Meeting Agenda

Historic Zoning Commission

Monday, March 10, 2025

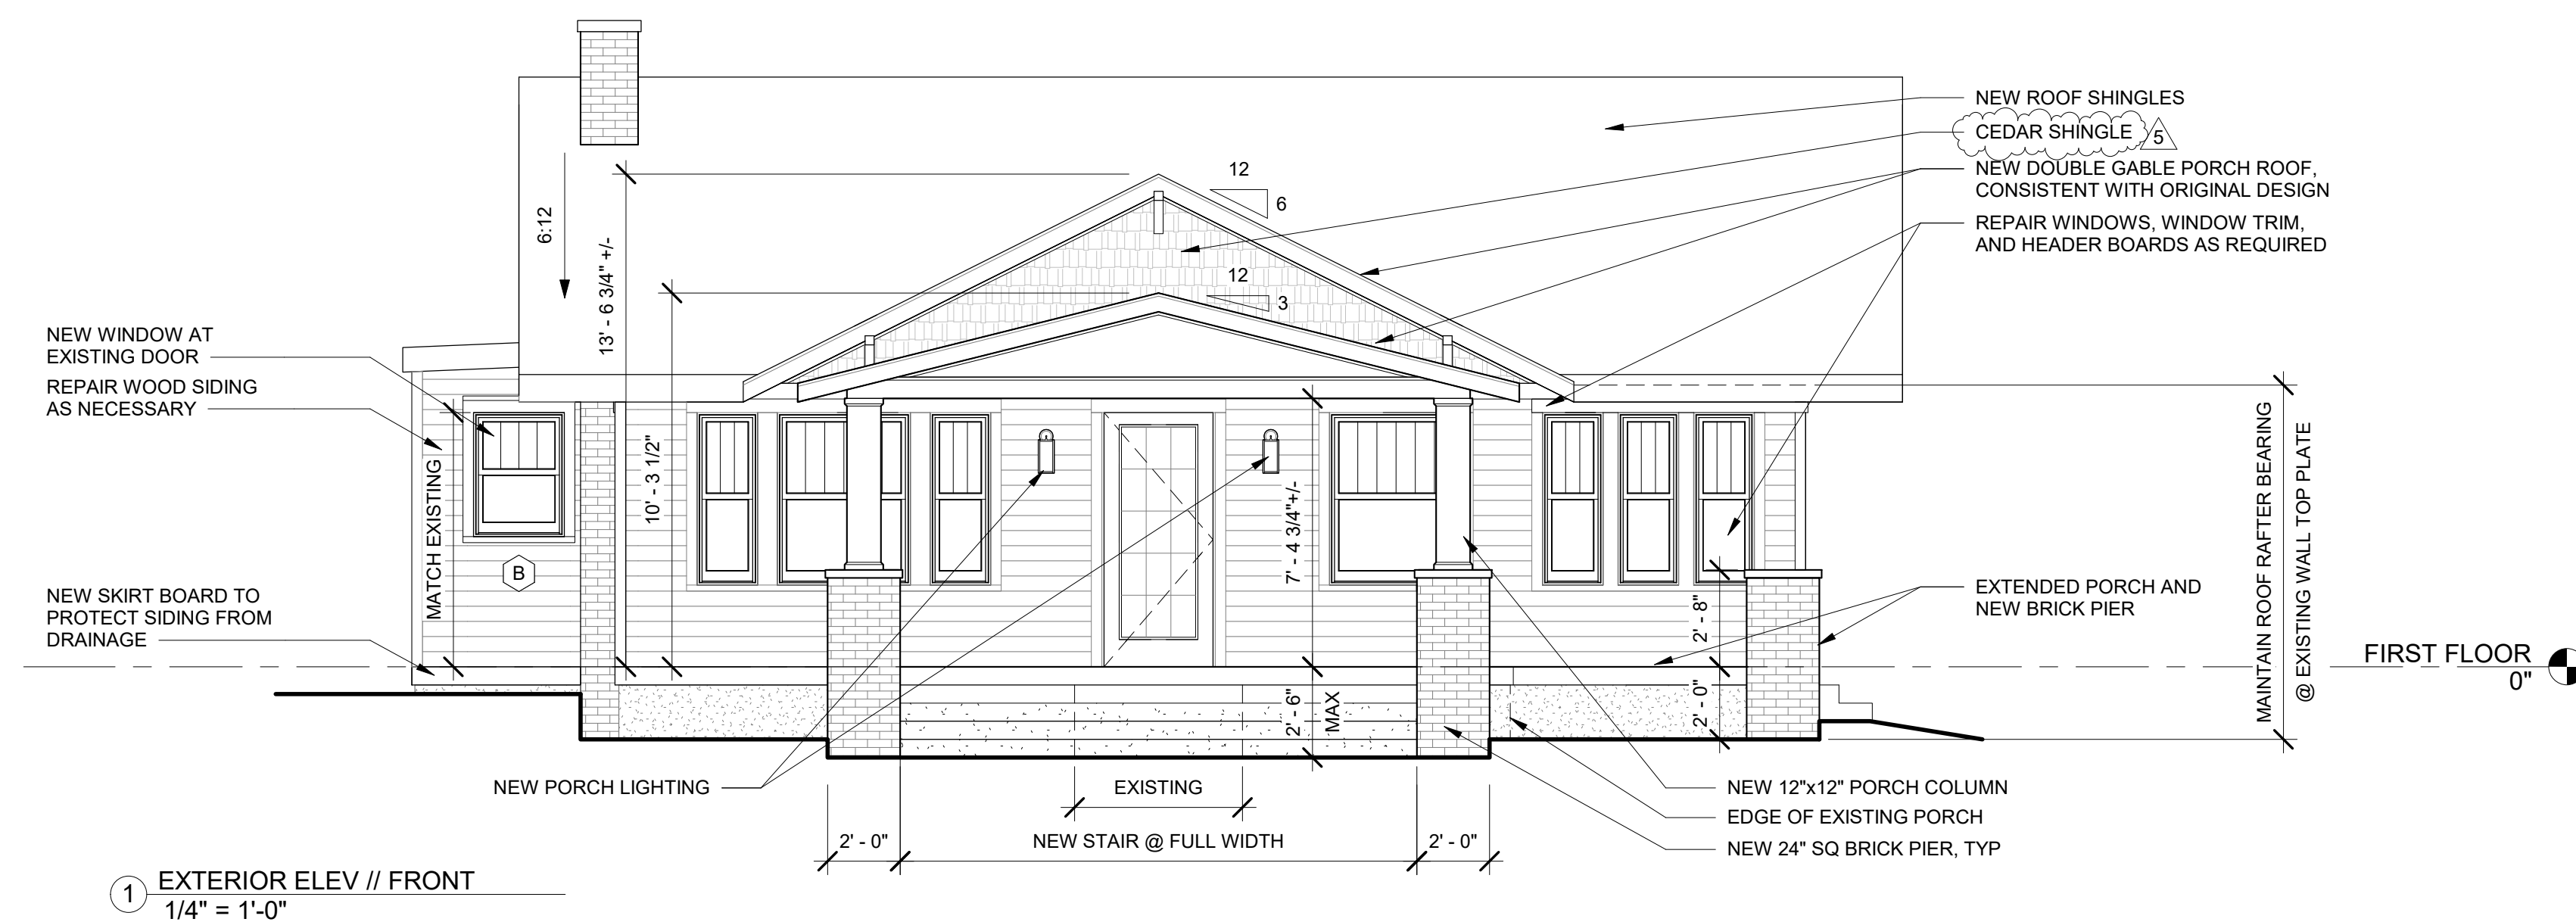
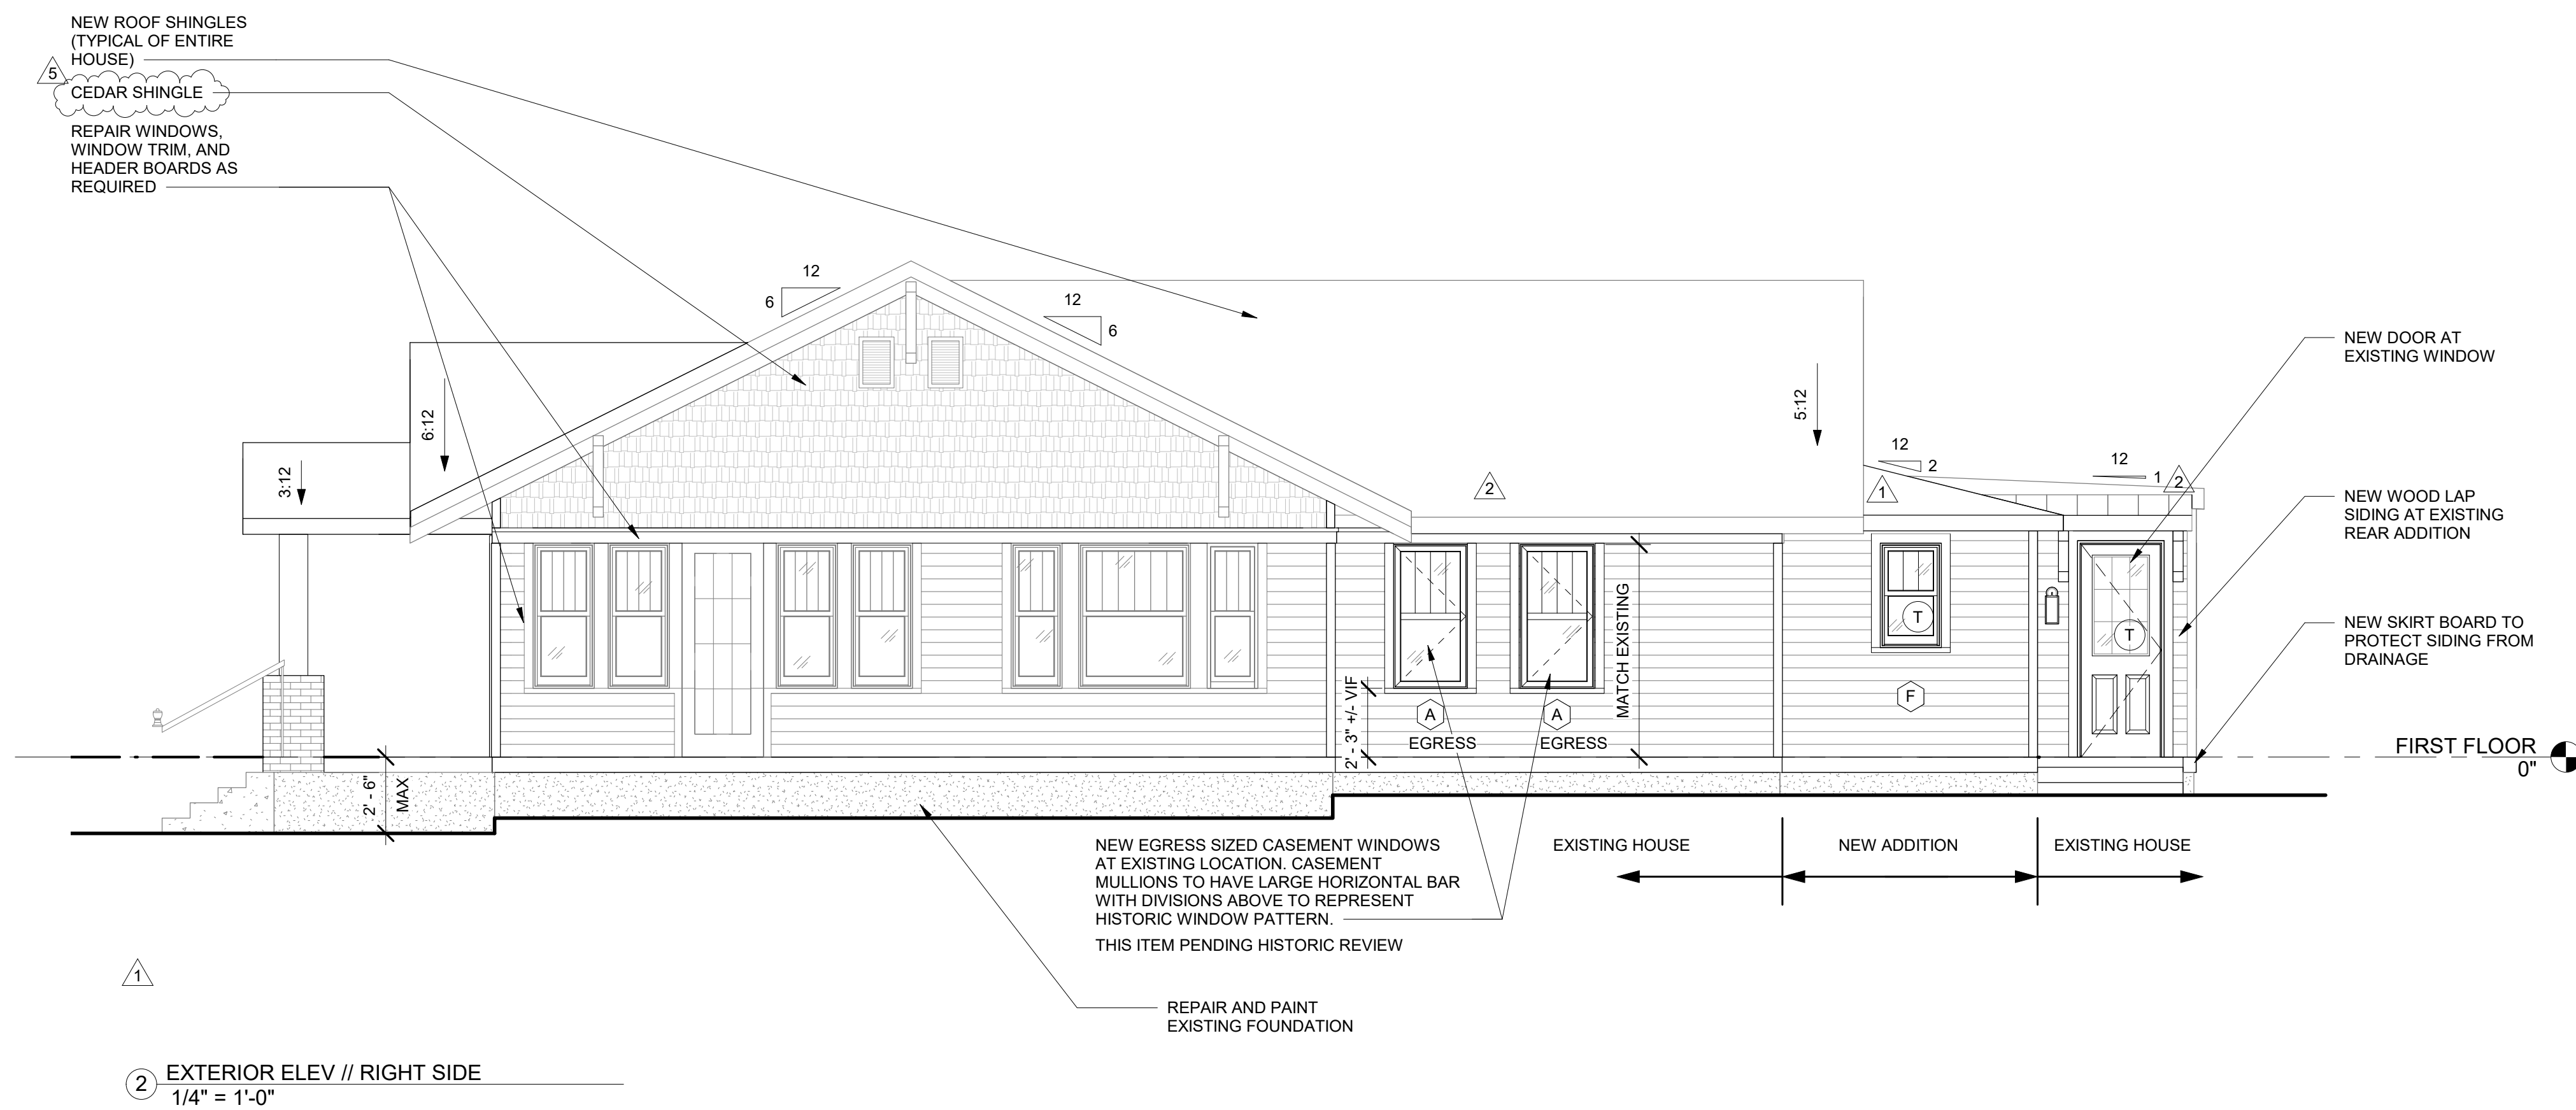
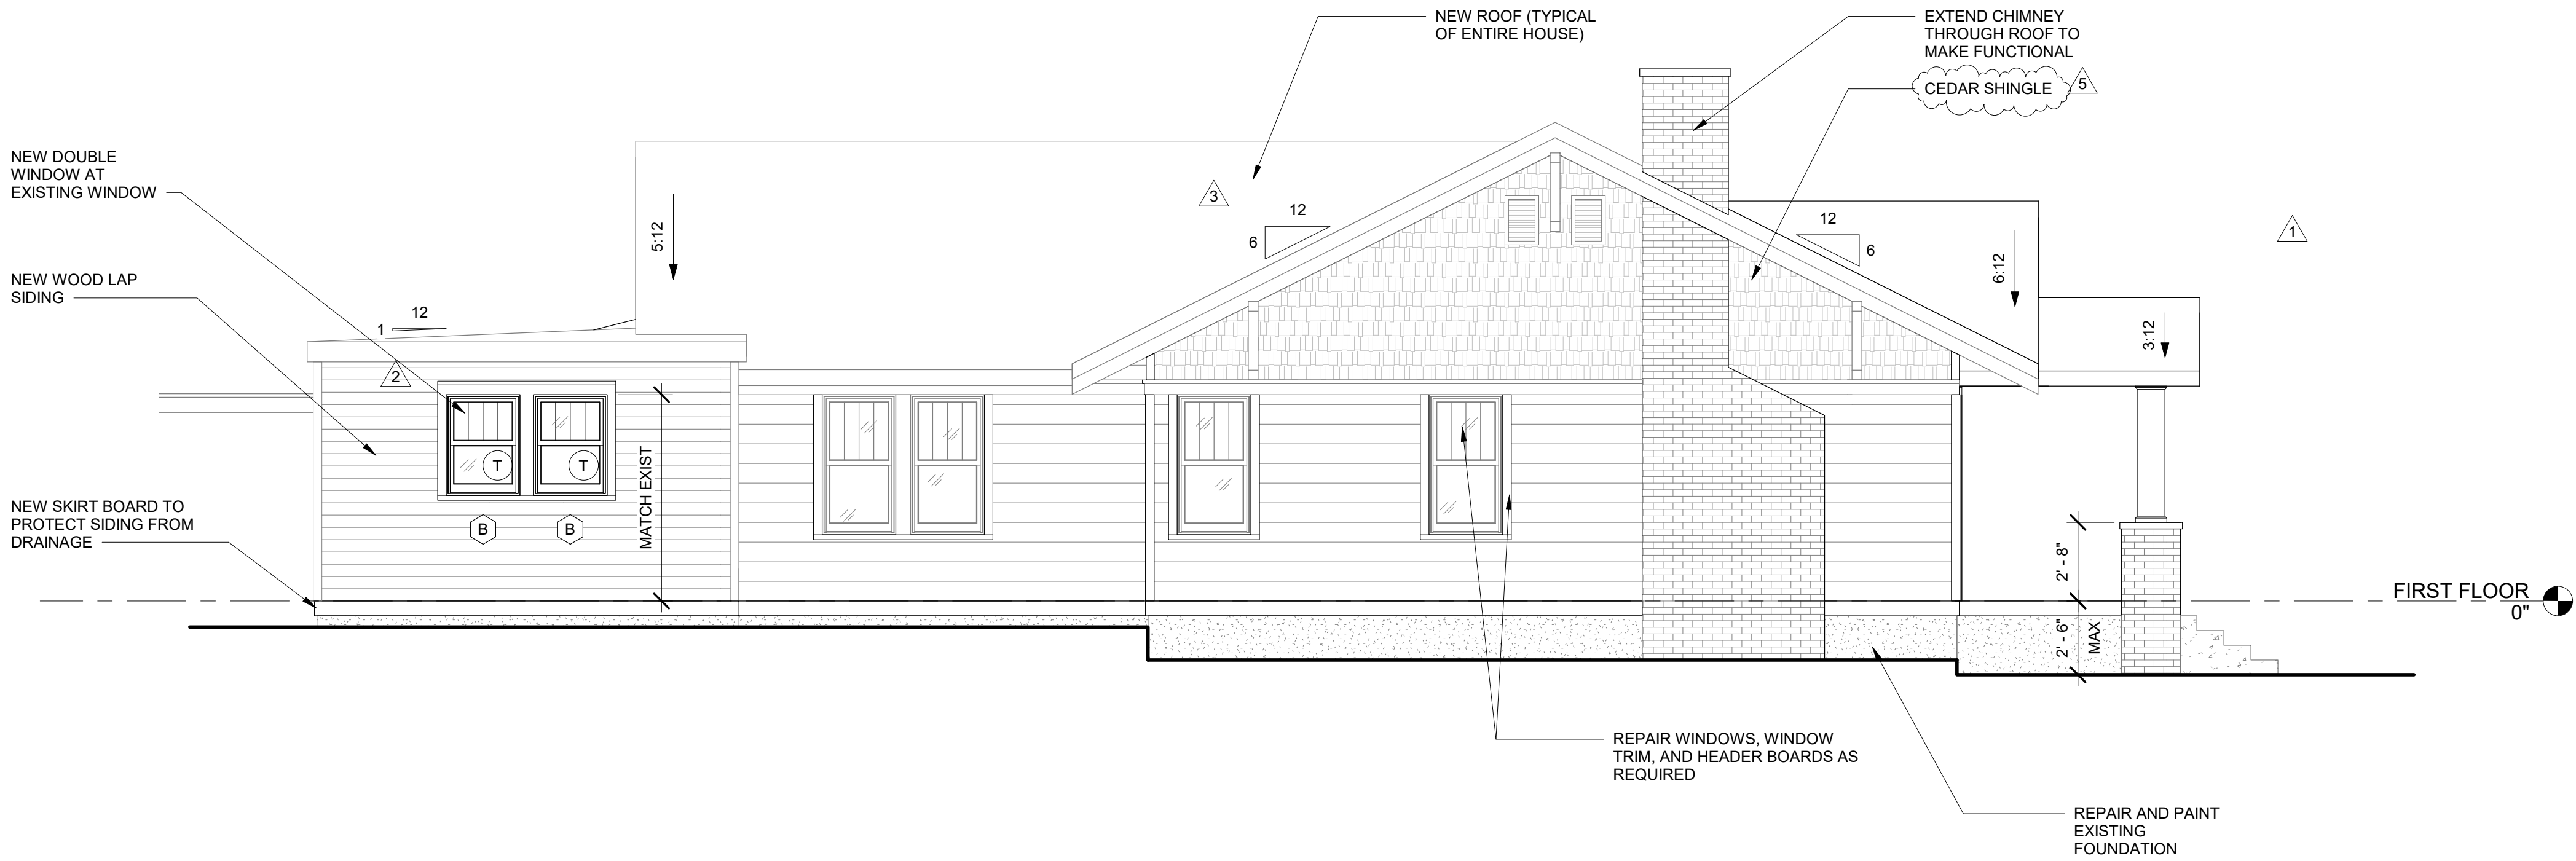
Included within the first COA issued in March of 2023, cedar shake was approved for the siding material on the entirety of the historic principal building and on the accessory structure. Cedar shingle was discovered to have been the siding material underneath the asbestos siding during initial work on the building. In November 2023, the proposal returned to the commission with alterations, including using lap siding for the building of cedar shake and stucco in the front gable end. In January 2024, the proposal returned for a change in material to the accessory structure to be clad in all lap siding and not cedar shake and was previously approved.

The reintroduction of a material that intends to match a historic material to the building is appropriate. The applicant has also provided example images of local homes of the same style and with the same material combination. The change in material in the gable from the previously approved lap siding to cedar shingle is appropriate.
